| <b>DOCKETED</b>         |   |
|-------------------------|---|
| <b>Project Title:</b>   | STACK SVY03A Data Center Campus                                 |
| <b>Document Title:</b>  | STACK Responses to CEC Staff Data Request Set 4 - SVY03A Campus |

# RESPONSES TO CEC STAFF DATA REQUEST SET 4 (59-62)

STACK SVY03A Campus (23-SPPE-01)

Exhibit C-600 Preliminary Fire Access

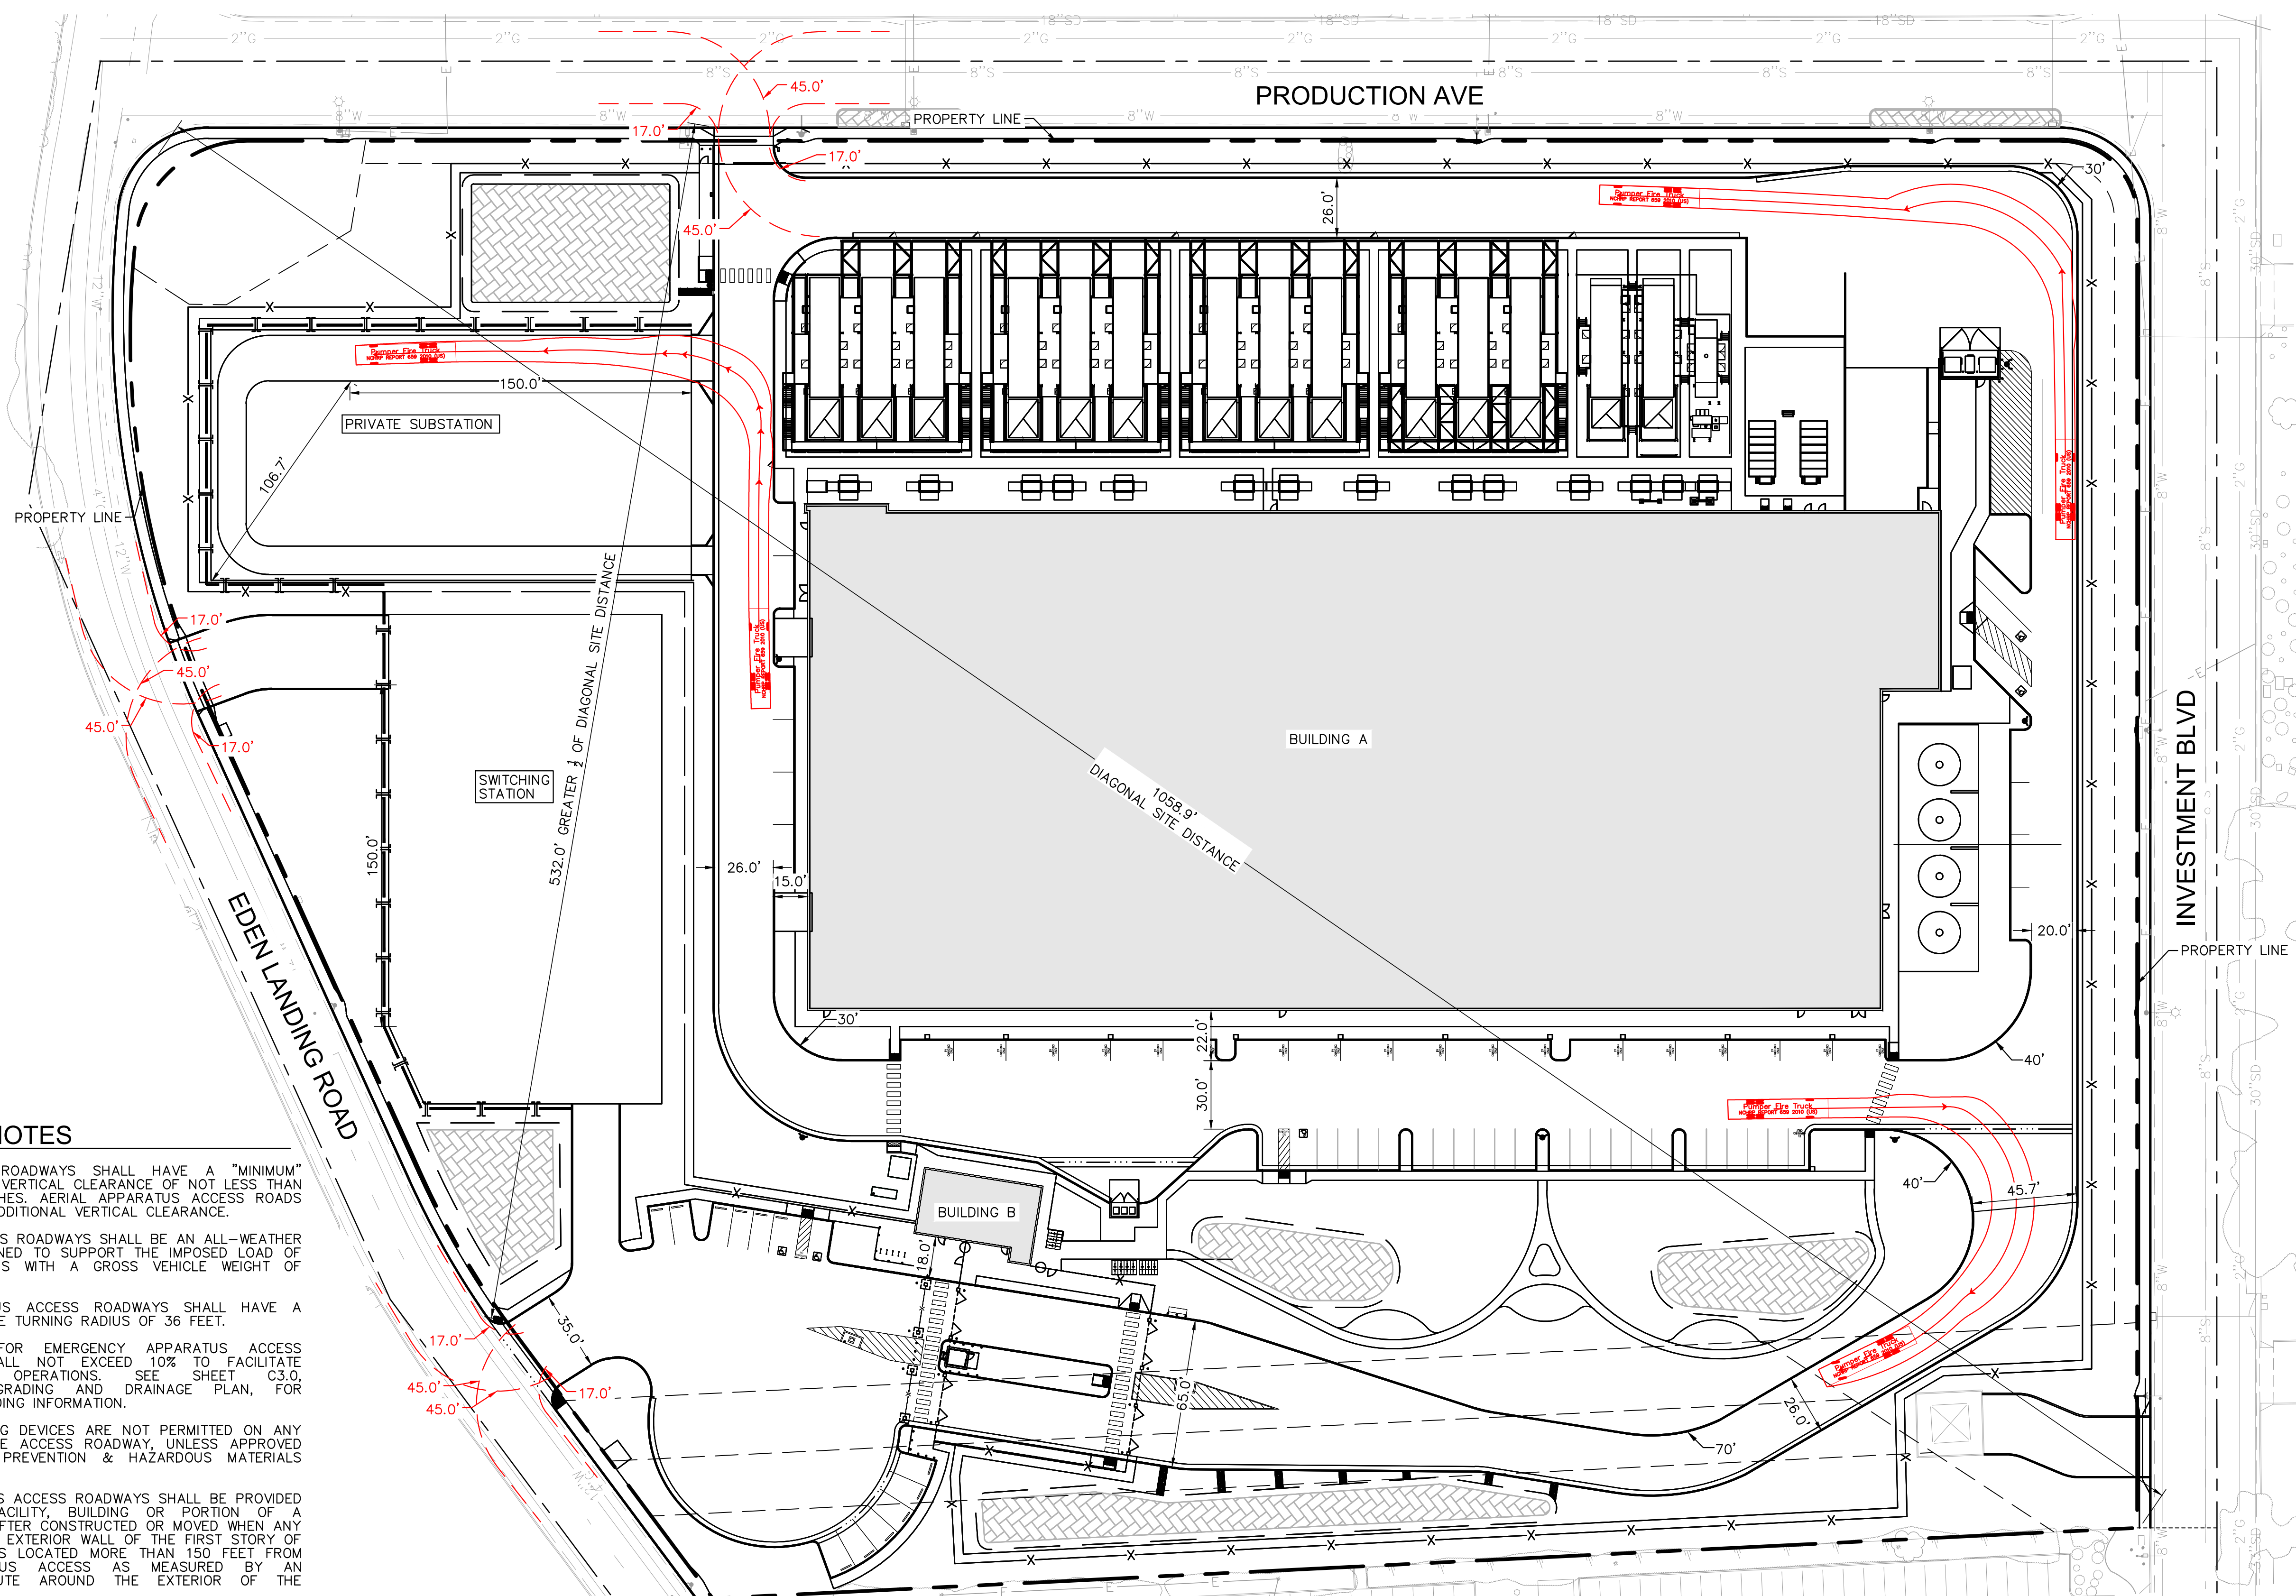
59. Provide truck turning templates for fire trucks entering and exiting the project site via entrances on Production Avenue and Eden Landing Road and navigating the project site.

Truck turning templates are provided in Exhibit C-600 as Attachment TRANS DR-59. The minimum inside radius is 17 feet and the maximum outside radius is 45 feet.

Exhibit C-700 Preliminary Truck Turning

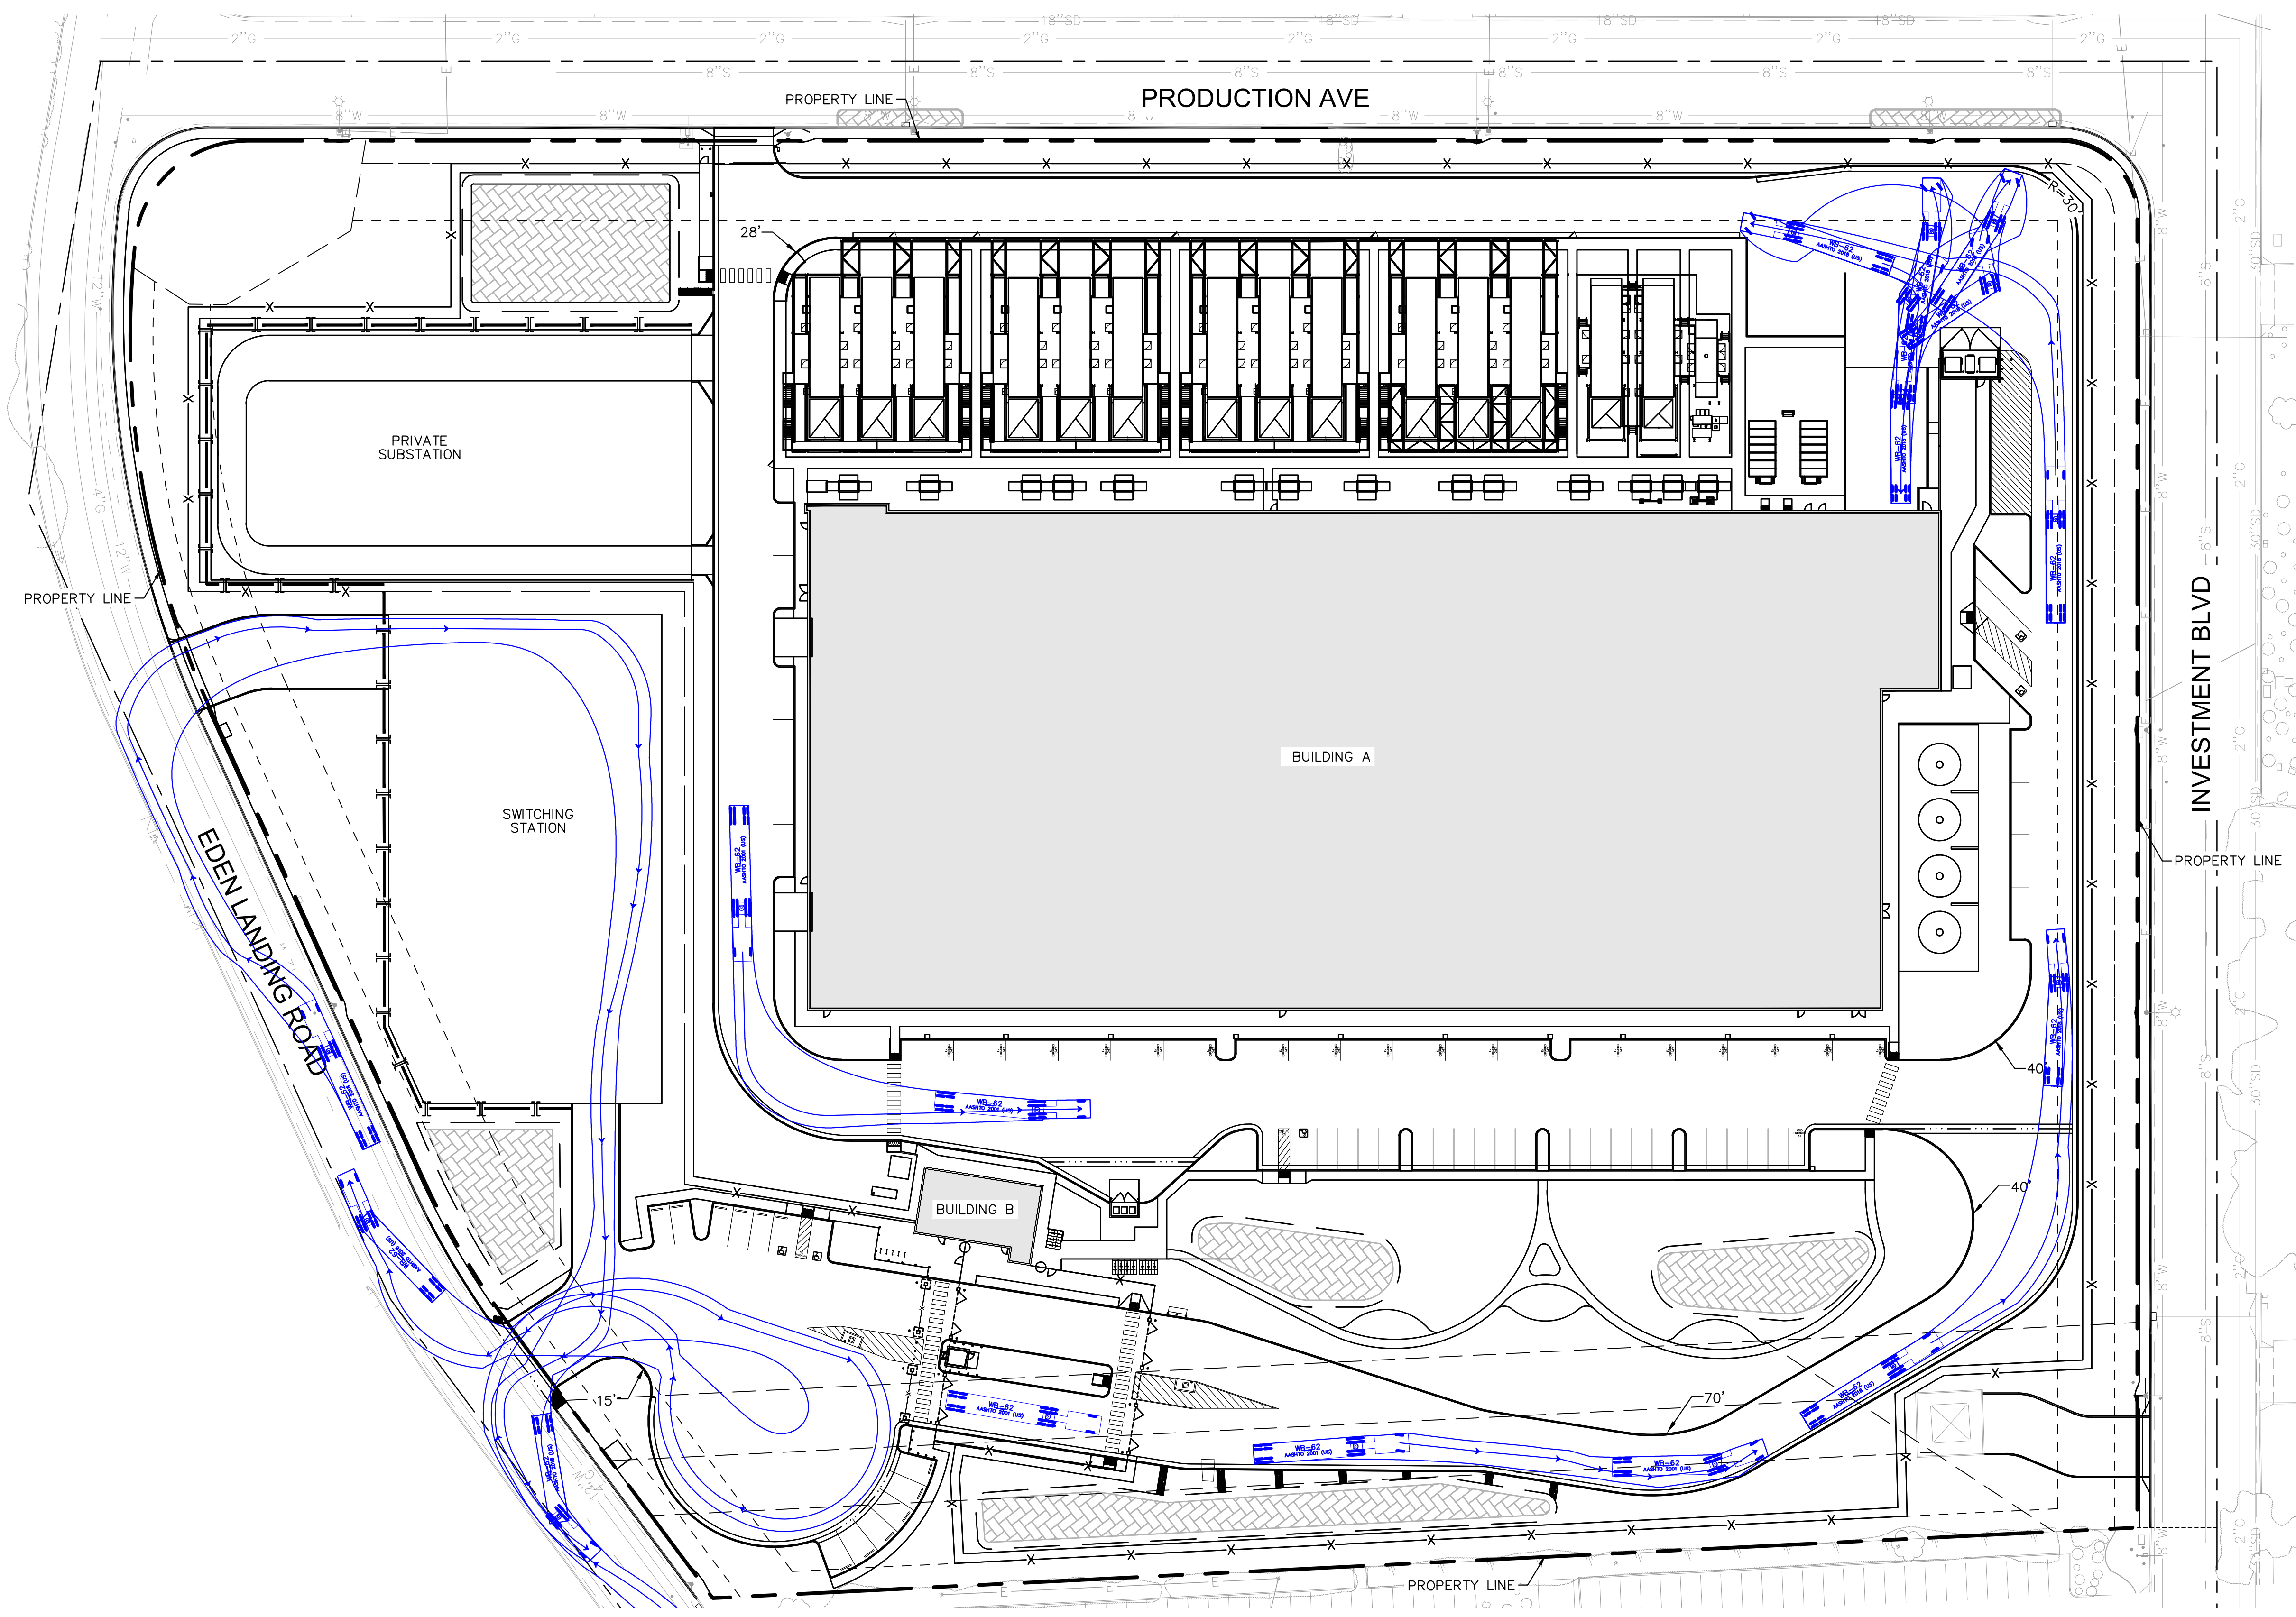
60. Provide a description of the vehicle types, and necessary maneuvers to which the 26-foot-wide driveway serving the switching station will be used, including turning movements for this driveway.

Turning movements for a WB-62 truck have been provided for access in and out of the switching station as well as around the site as shown in Exhibit C-700 Attachment TRANS DR-60.
